Year 1 Monitoring Report

APPLE VALLEY PROJECT

NCDMS Project #100063 (Contract #7531)

RE: Apple Valley Site: Year 1 Monitoring Report

MY1 2021 Apple Valley Stage Recorder AV1 Stream Overbank Hydrograph

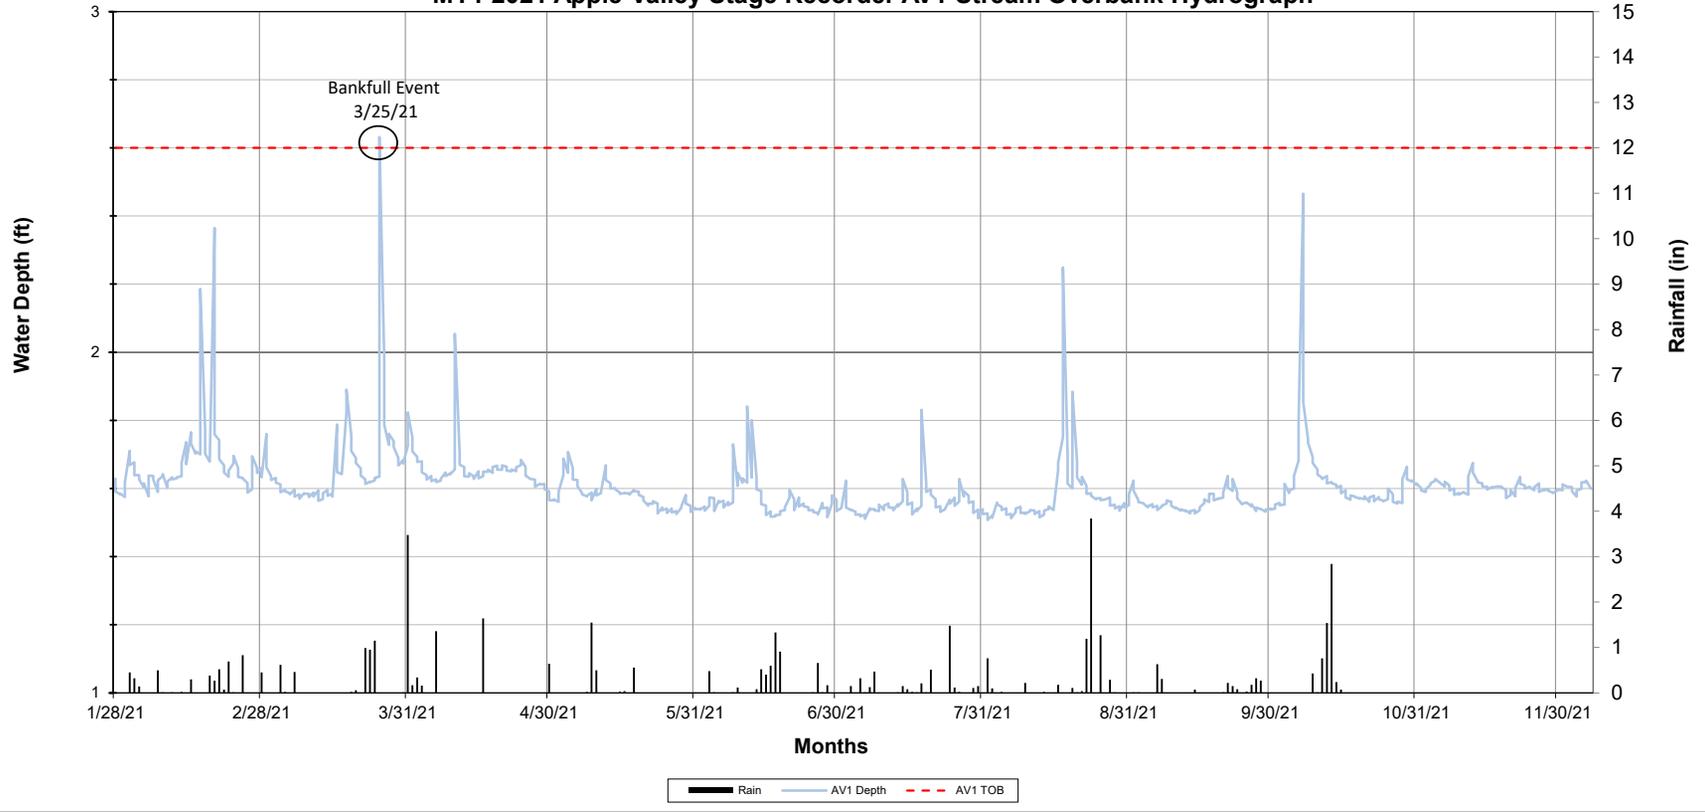
Please include a figure in the report displaying the overbank continuous stage recorder data.

A figure displaying data for the overbank continuous stage recorder has been included in **Appendix E**.

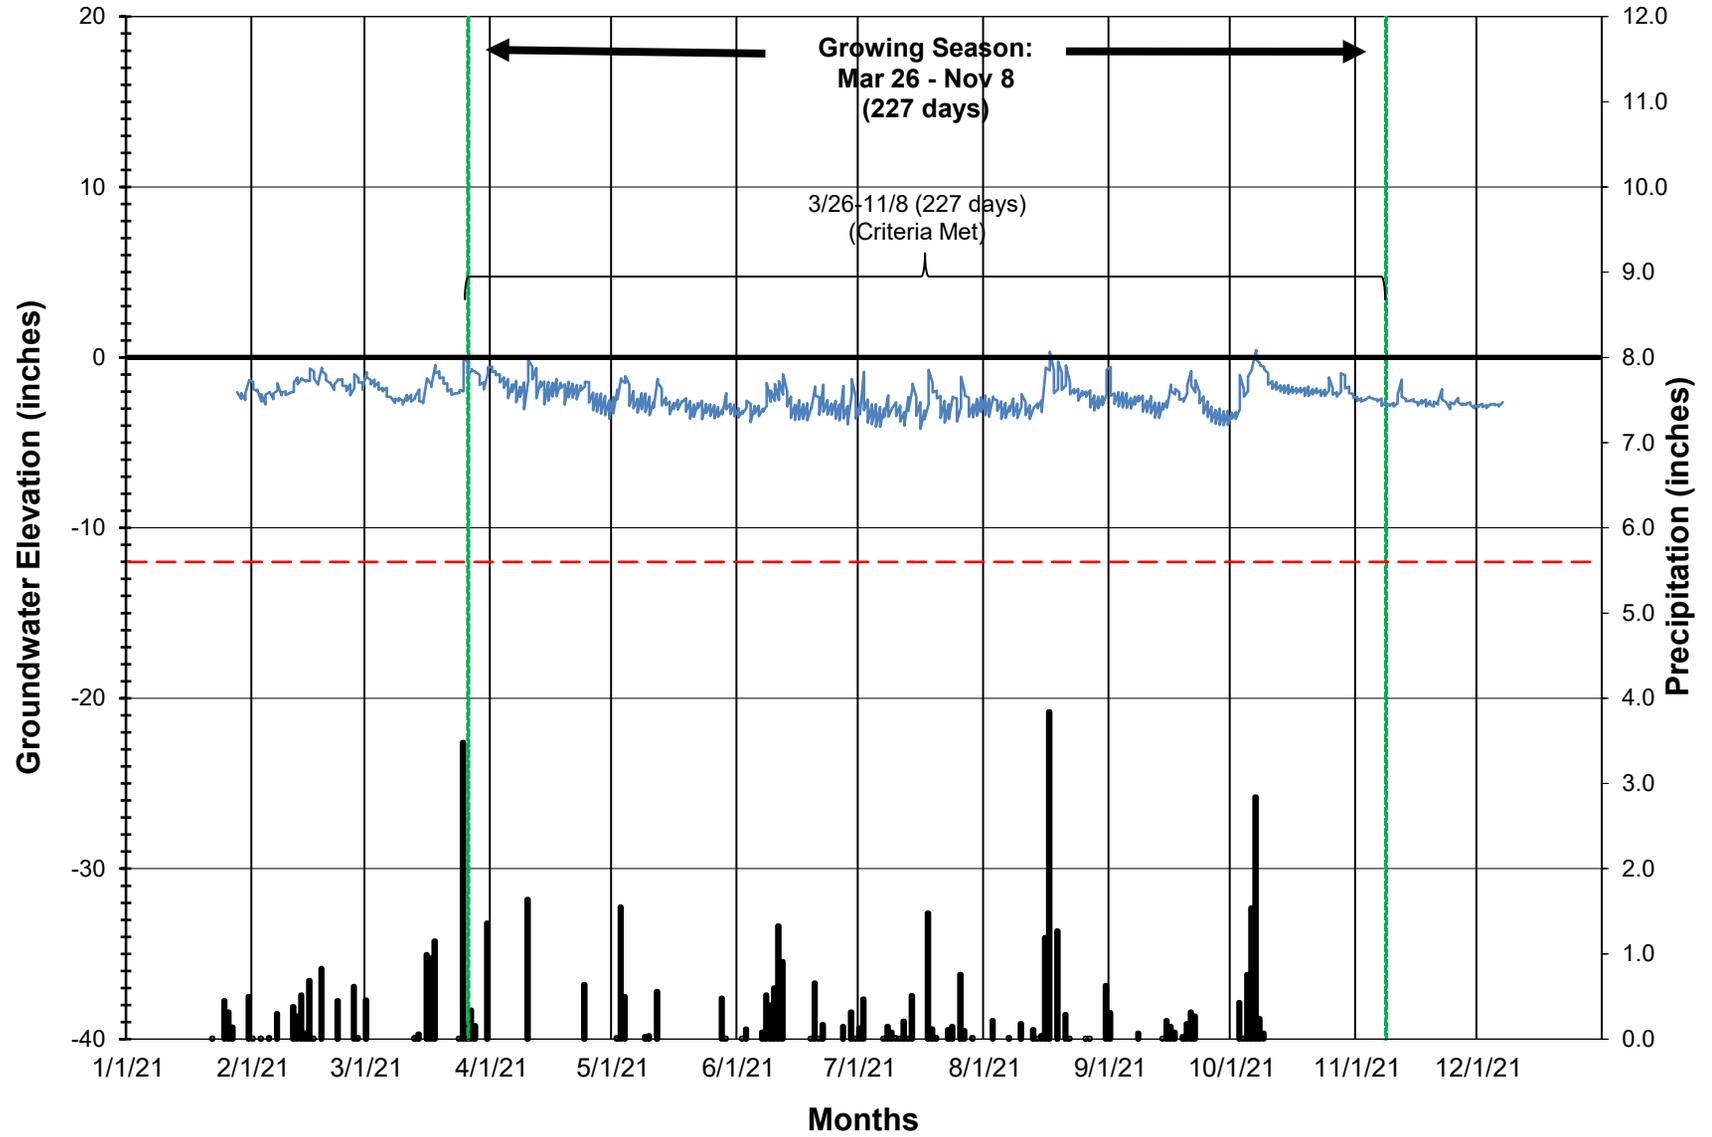
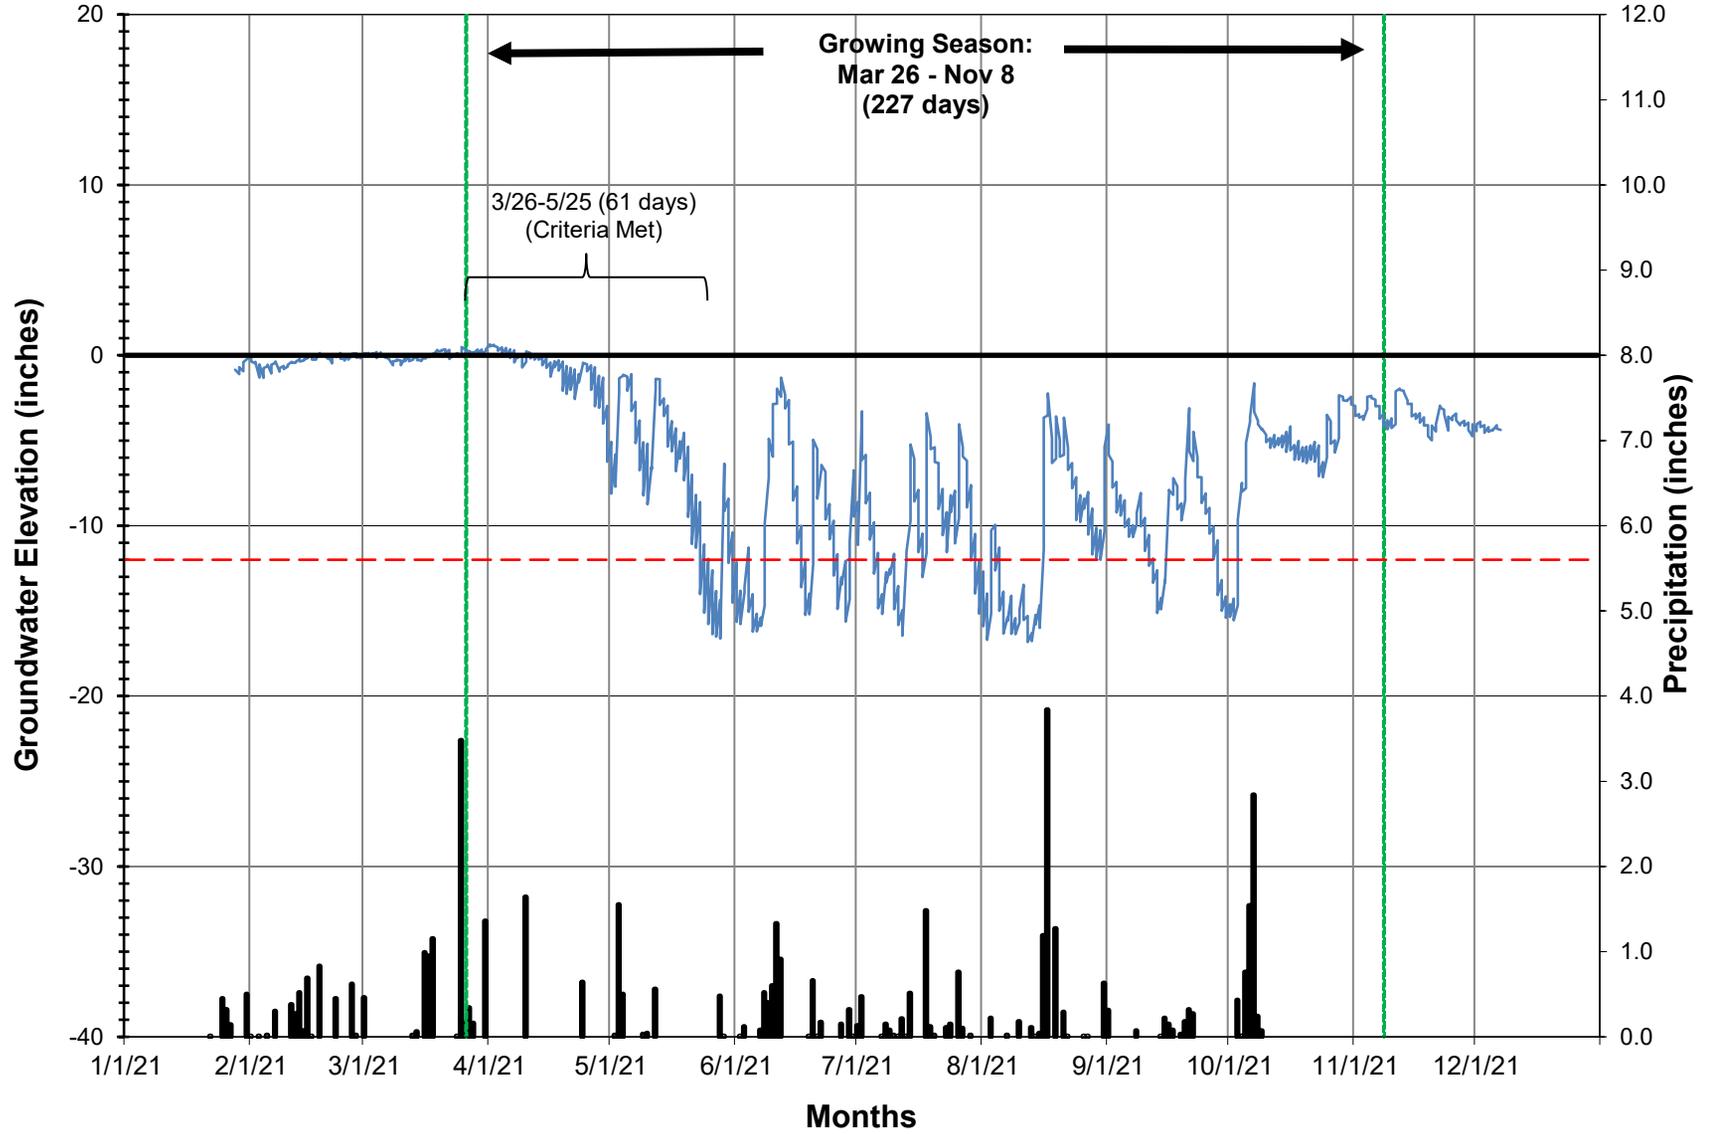
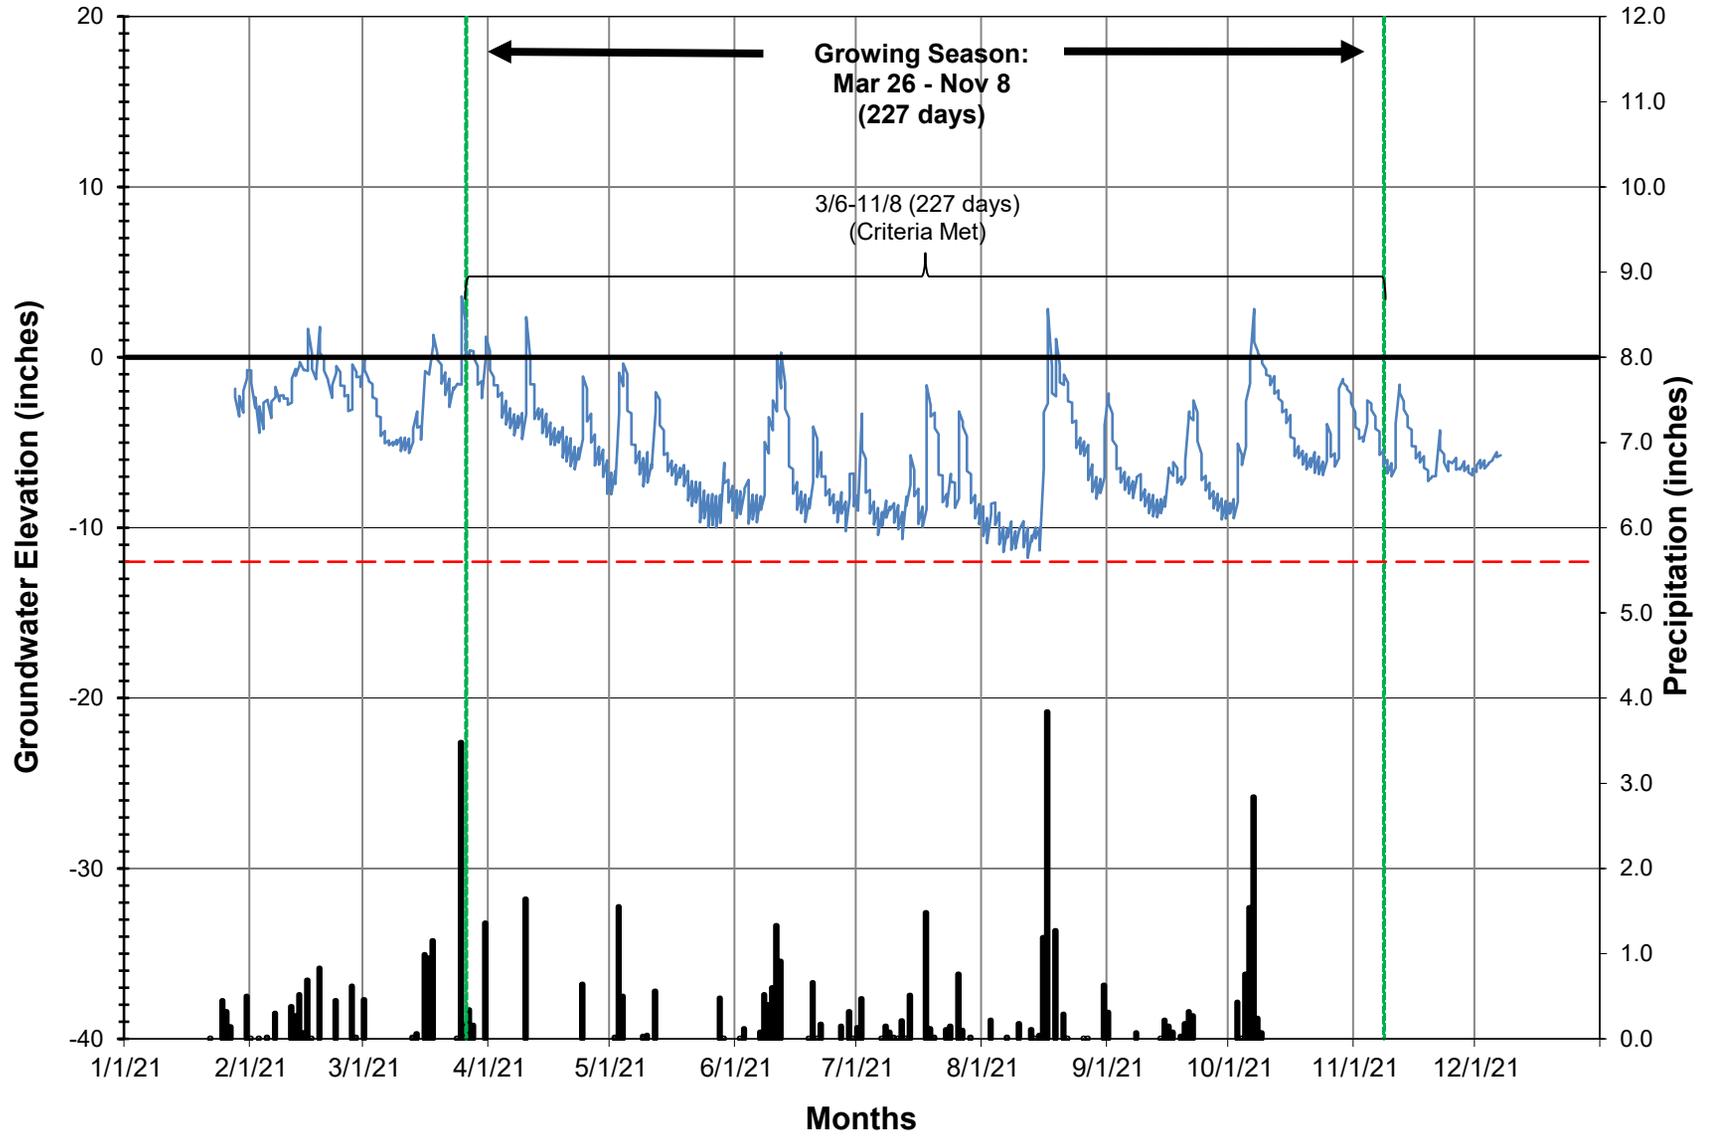
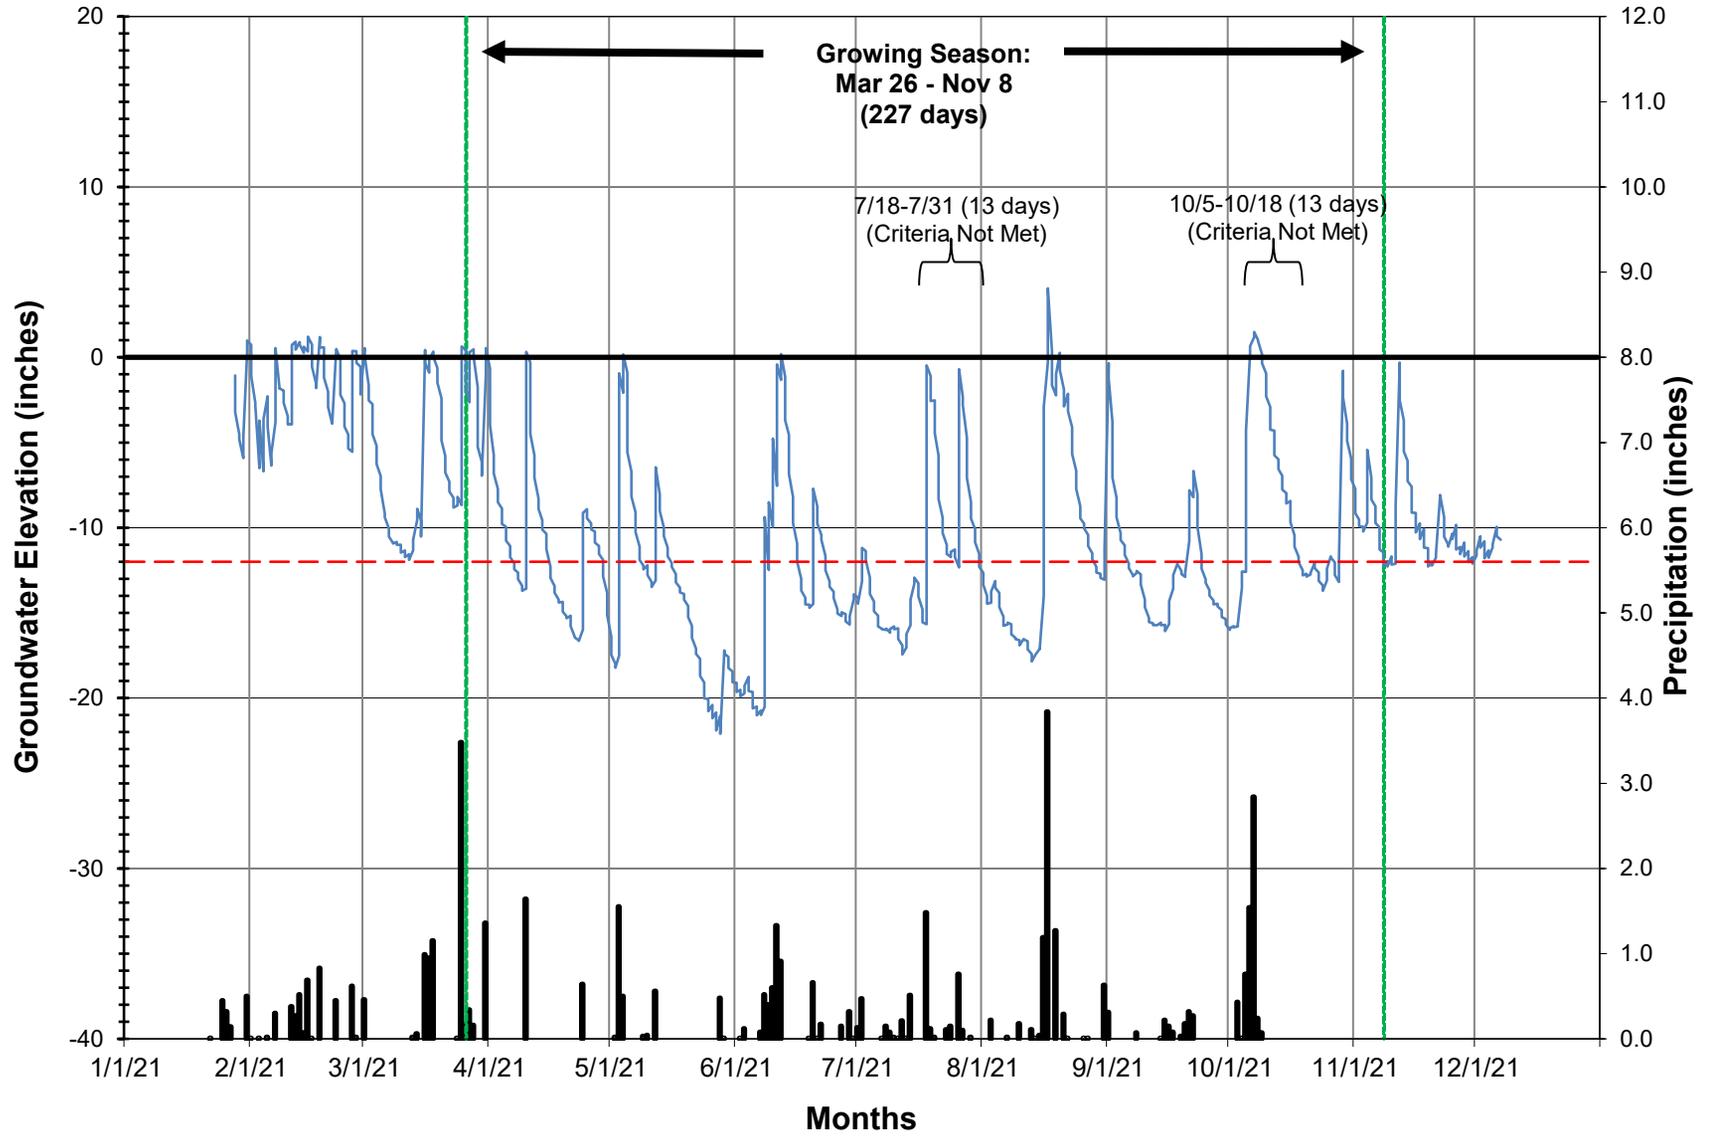
On the GW gage graphs – It would be helpful to show a few more details on the graphs. Please indicate which line is the criteria level. It appears to be a similar line style as the rain levels. Also, it would be helpful to list the date of the growing season on the graph, and during which maximum period the criteria were attained, or that criteria were not attained; and other notes as needed.

The criteria level (Jurisdictional Water Table) has been depicted with a red dashed line and added to the legend for reference. The growing season dates have been added to each groundwater well graph (Mar. 26 – Nov. 8). A bracketed note with the maximum hydroperiod (with an indication of whether or not the criteria was met) has been added to the graphs.
